Jet Zero

RESPONSE TO COORDINATOR-GENERAL REQUEST FOR ADDITIONAL INFORMATION

PROJECT ULYSSES
RFI NUMBER: APP-002/2025

TQ/RFI number:	APP-002/2025	Project title:	Project Ulysses
Requestor	Steffen Poetzsch, OCG	Response by:	Jet Zero – Approvals
Date of request:	16/7/2025	Date of response:	31/10/2025

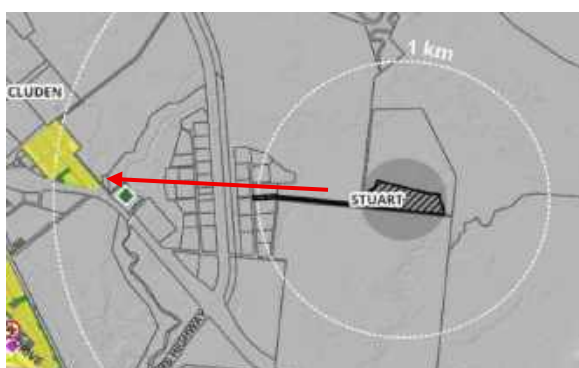
The FEA report states that hazards are largely contained on-site, however the report contains diagrams that show multiple contours extending beyond the site's boundaries. A visual demonstration of off-site hazard impacts is requested to understand the extent and nature of potential impacts.

(1) Provide hazard contours (thermal radiation, explosion overpressure, toxic gas dispersion) relative to site boundaries, land use zones (sensitive/vulnerable/industrial), roads and adjacent facilities (where applicable).

The hazard contours, including those extending beyond the site boundaries (as shown in Figures 17 to 19 of the Planning Report, and the FEA appended to that report), demonstrate that for all scenarios, hazards are largely contained within the site, with only a small area extending beyond the boundaries. These areas, as demonstrated by the consequence scenarios are limited in extent, do not impact occupied or developable

Figure 16 of the development application identifies the locations of surrounding sensitive receptors, with the nearest receptor situated approximately 2.3 km (Big 4 Holiday Park) and 2.6 km (residential areas) to the east of the nearest development boundary, as indicated by the red arrow below:
